# **London 2012 Olympic Park**

Consolidated Validation Report (Stage 3) -  
Planning Delivery Zone 2

**July 2013**

Drawing 2: PDZ2 Common Domain Overlay

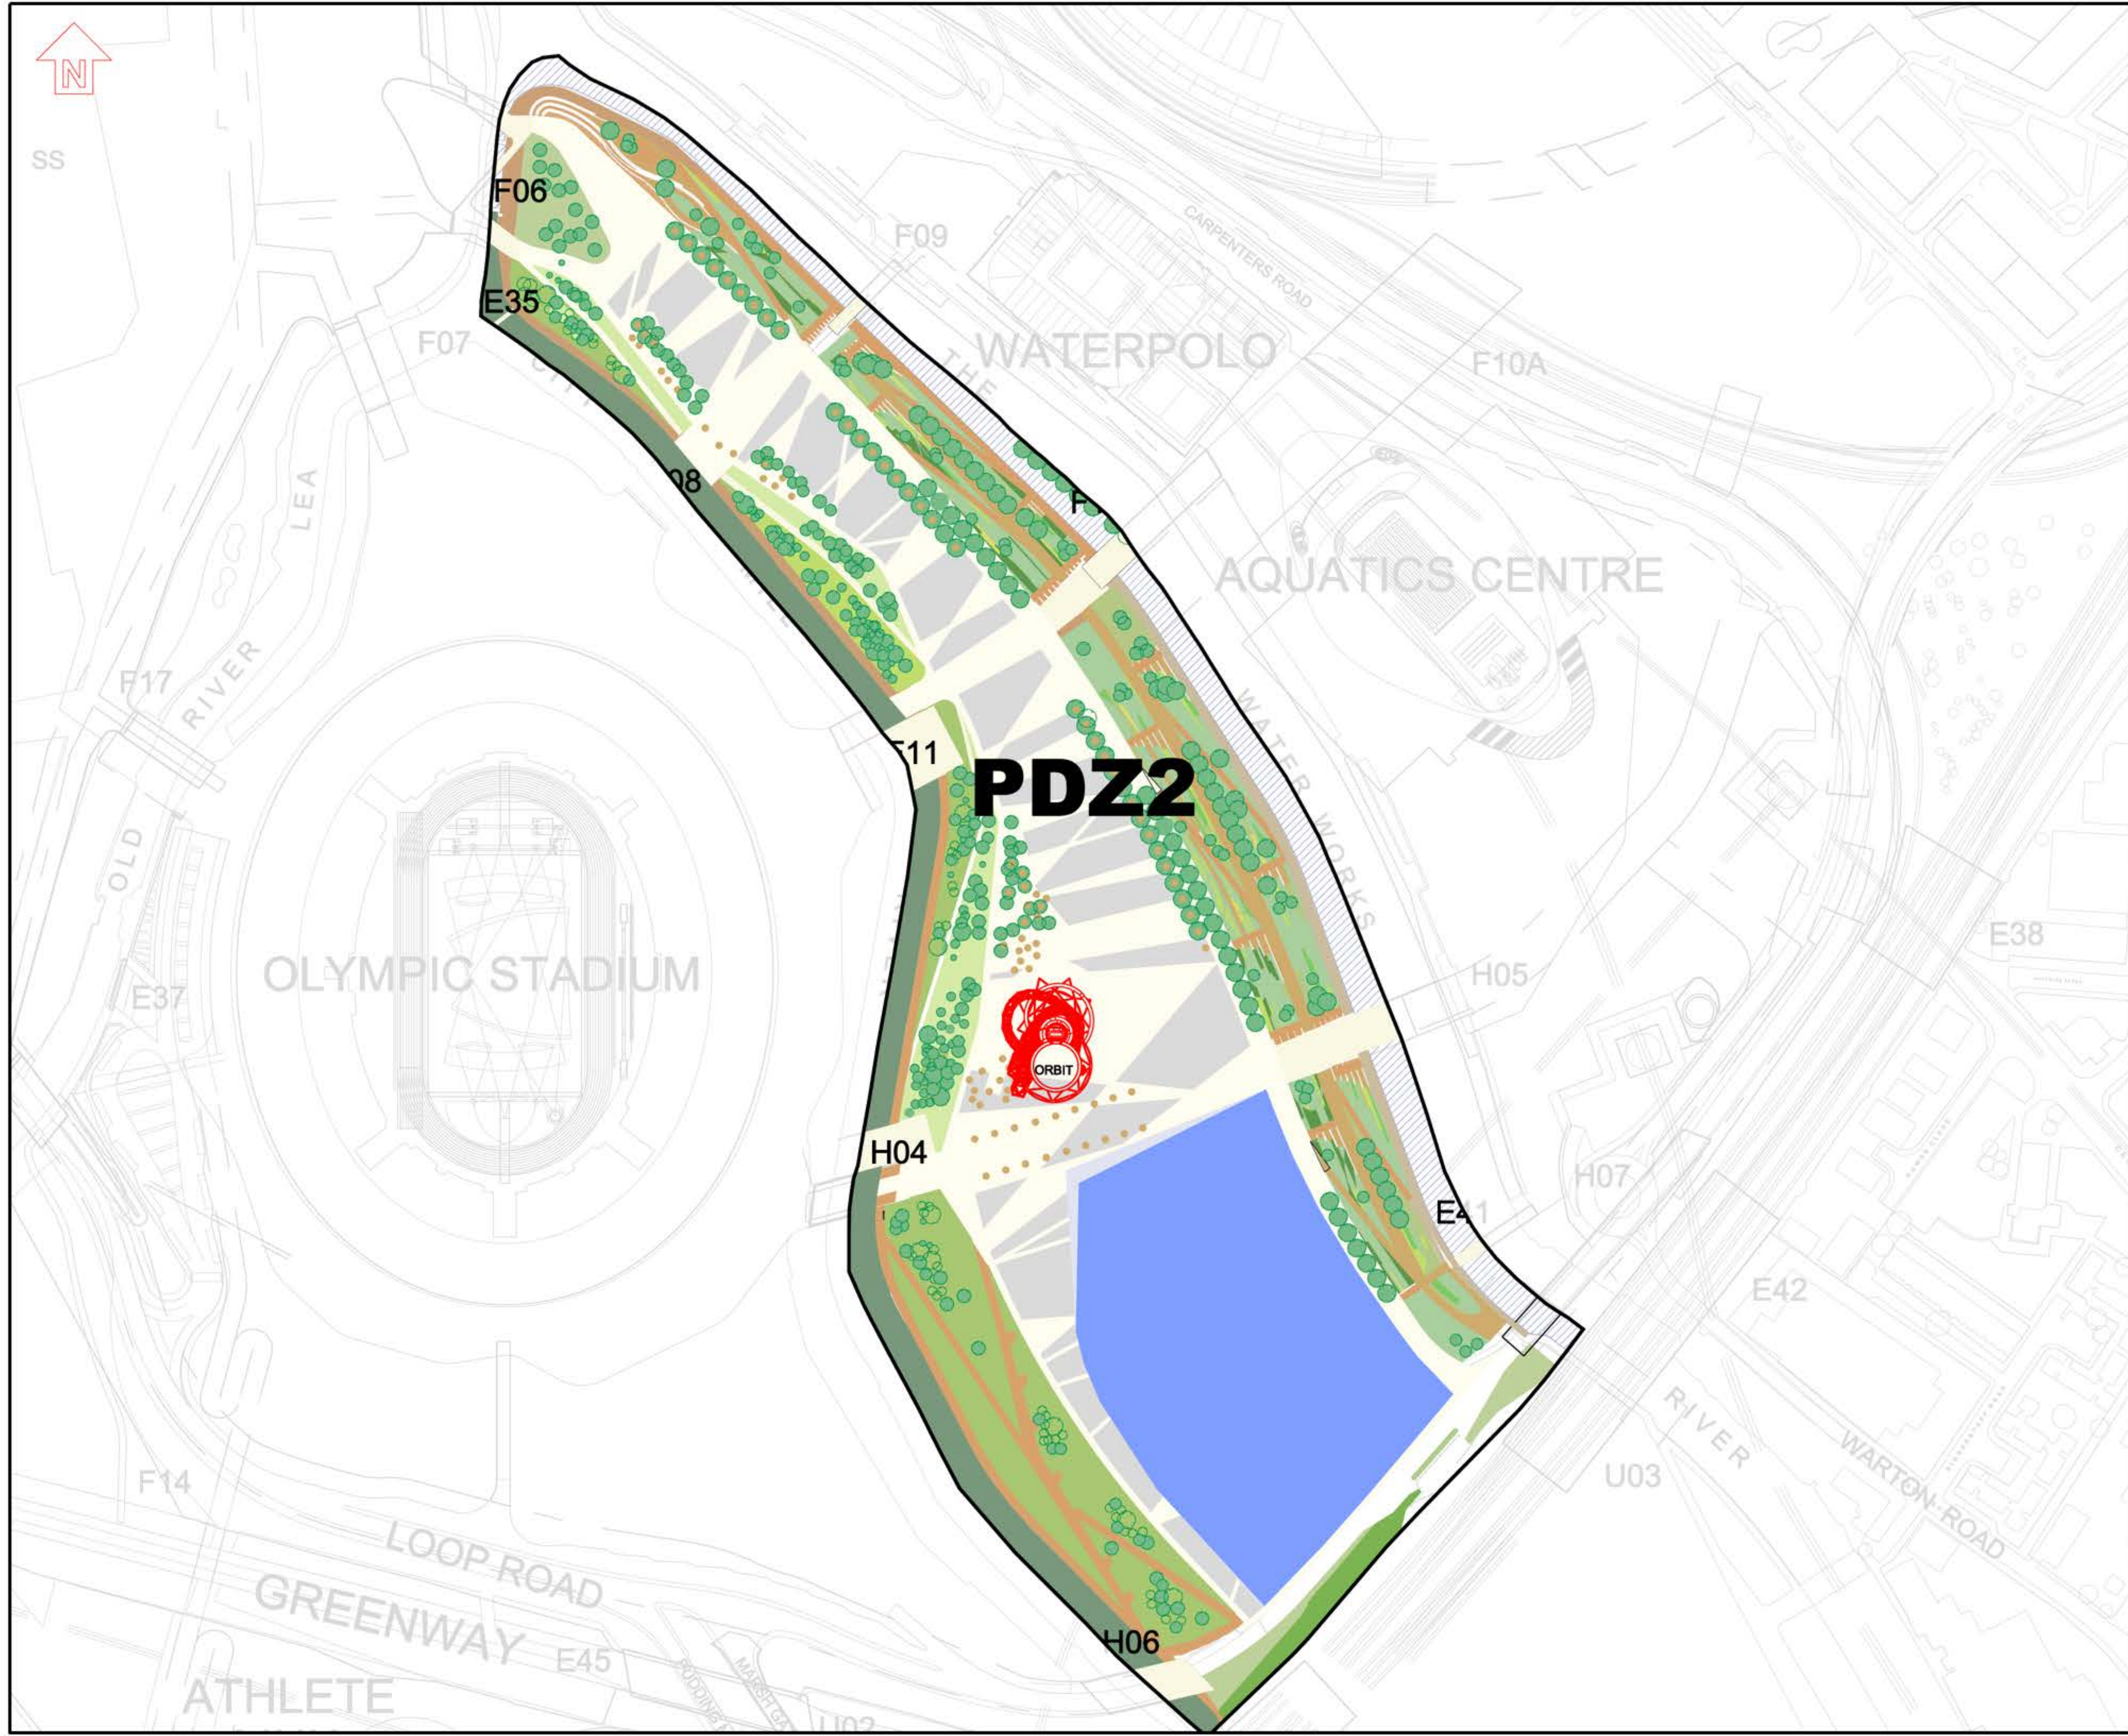
Ref.	Submission Section / Aspect	HCL Comment <b>LOCOG Response 11/10/12</b> Hyder Review 23/10/12 <b>LOCOG Response 11/12/12</b> Hyder Review 13/12/12
1.1	Drawings 1 and 2	Please add the redline of the site being validated, approximate if necessary. A hand-drawn mark-up will be adequate, so no new CAD work is required. <b>Hand drawn sketch will be provided with approximate boundaries.</b> Hyder: Please amend the final report accordingly. Assuming this is done, no further comment. LOCOG 11/12/12: Please see revised Drawing 2 of the enclosed Final Stage 3 CVR detailing the redline boundary. Hyder: Drawing 2 has been updated to show redline. No further comment.

Drawing Title  
**Figure 3 Legacy End Use for Planning Delivery Zone 2**

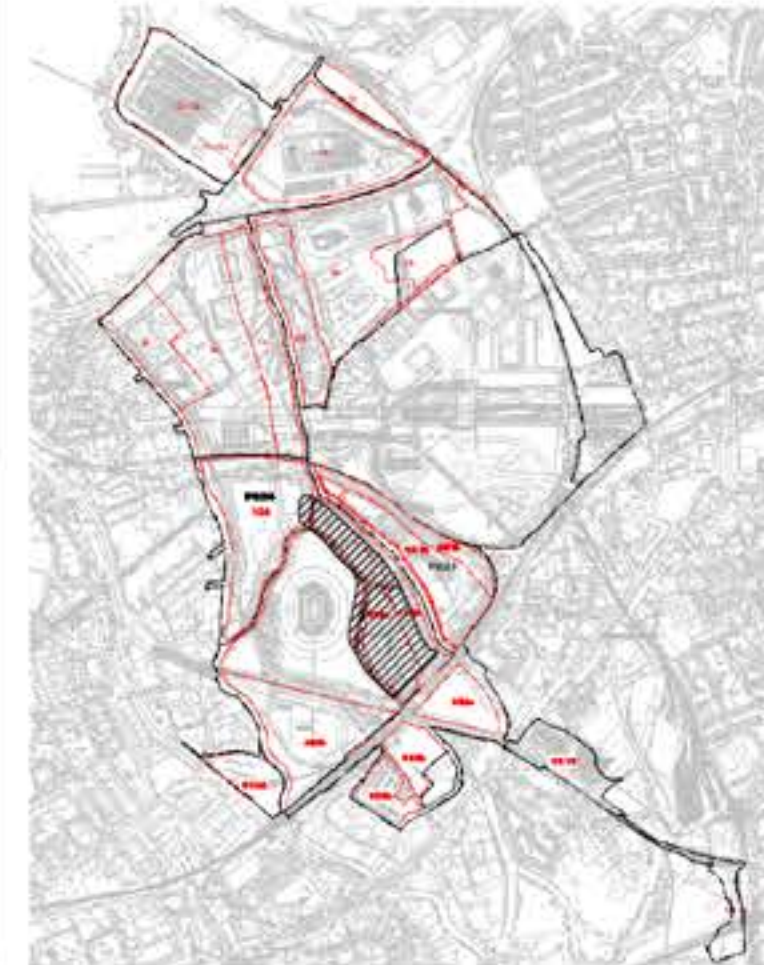
1.2	Drawing 4	Is this plan relevant given LOCOG’s Olympic only responsibility. If this plan is considered necessary, we suggest that the Legacy plan from the Stage 2 CVR replaces the EDAW plan which may not be up to date. <b>It provides context, but happy to remove drawing.</b> Hyder: Please amend the final report accordingly. Assuming this is done, no further comment. LOCOG 11/12/12: Drawing 4_SKE-EDW-UD-ZZZ-ZZZ-XXX-CA0006 has been removed and replaced by the Legacy plan from the Stage 2 CVR (0241-ENW-PWD-C-DGA-0203). Hyder: No further comment.

Locoq / Showcase  
VALIDATION AREAS

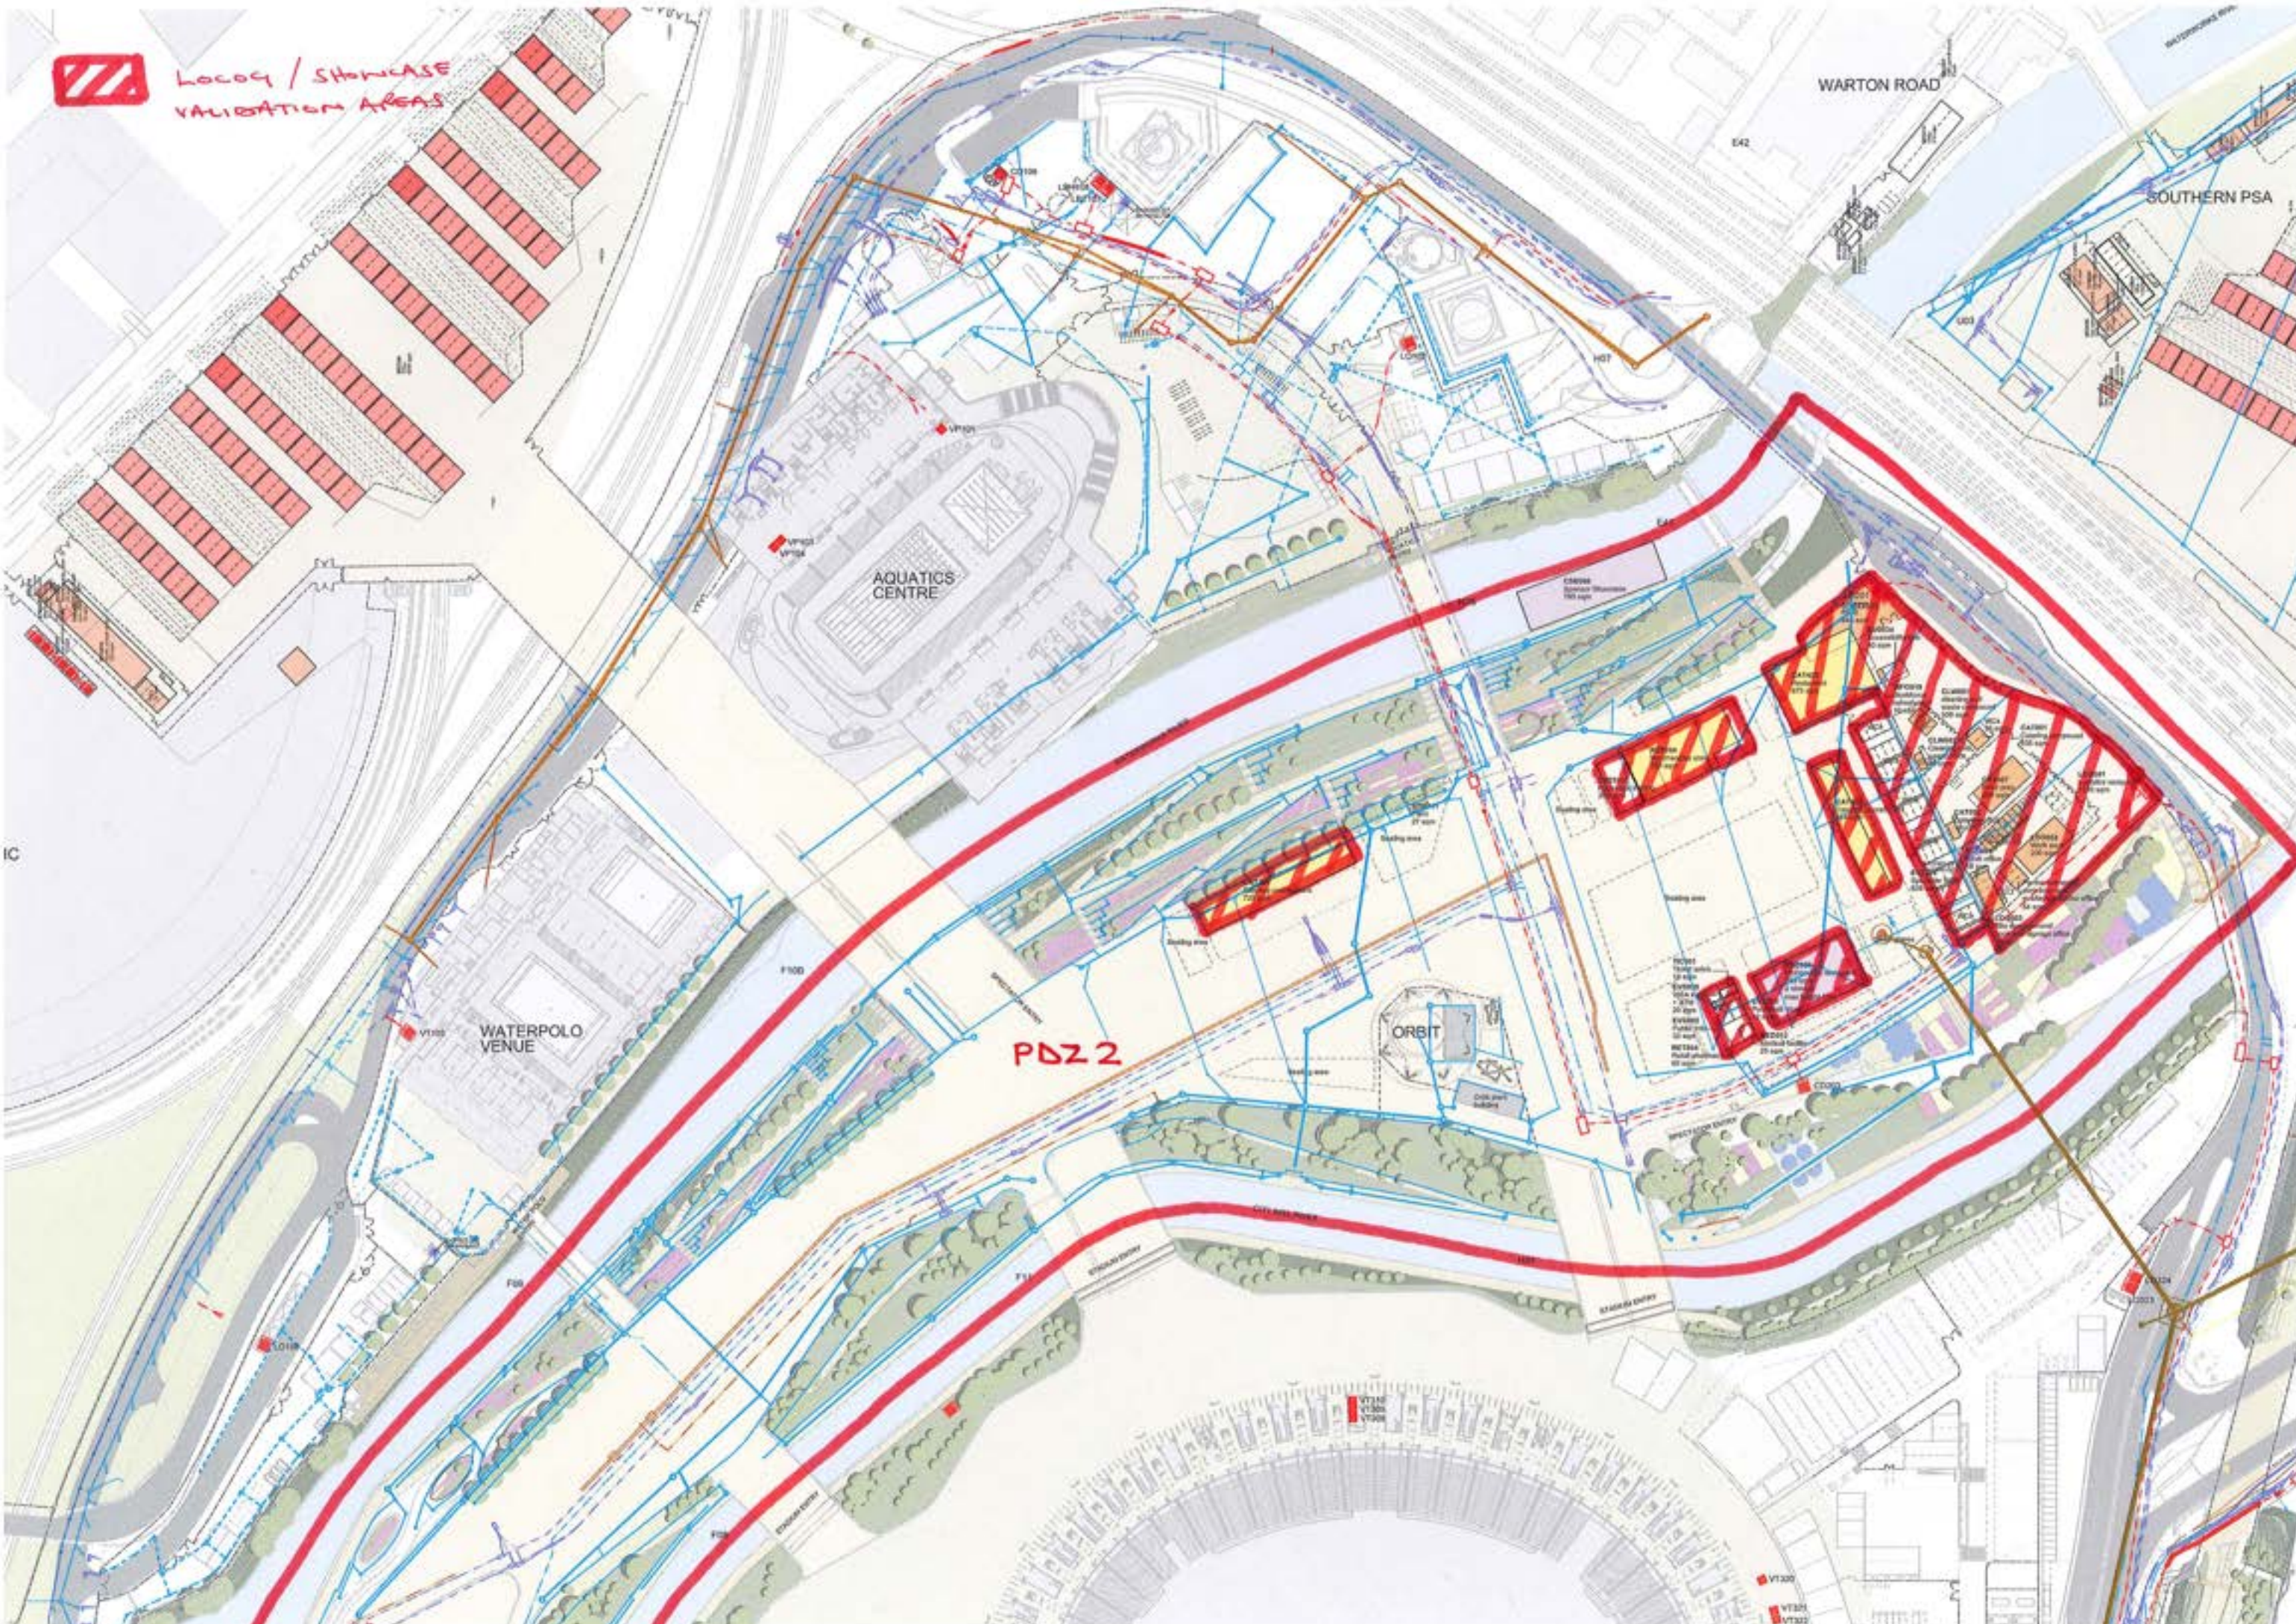
1.20	Spatial coverage of reports	<p>A simple drawing showing the spatial extent of the LOCOG / Showcase validation reports should be included in the report, even if a hand-drawn mark-up.</p> <p><b>This drawing referred to above will be provided showing the approximate location of the area being validated.</b>  Hyder: subject to review of the drawing, no further comment.  LOCOG 11/12/12: Please see new Drawing 7_Plan of LOCOG &amp; Sponsor Showcase Validation Areas.  Hyder: Drawing 7 has been provided confirming location of validation areas. No further comment.</p>
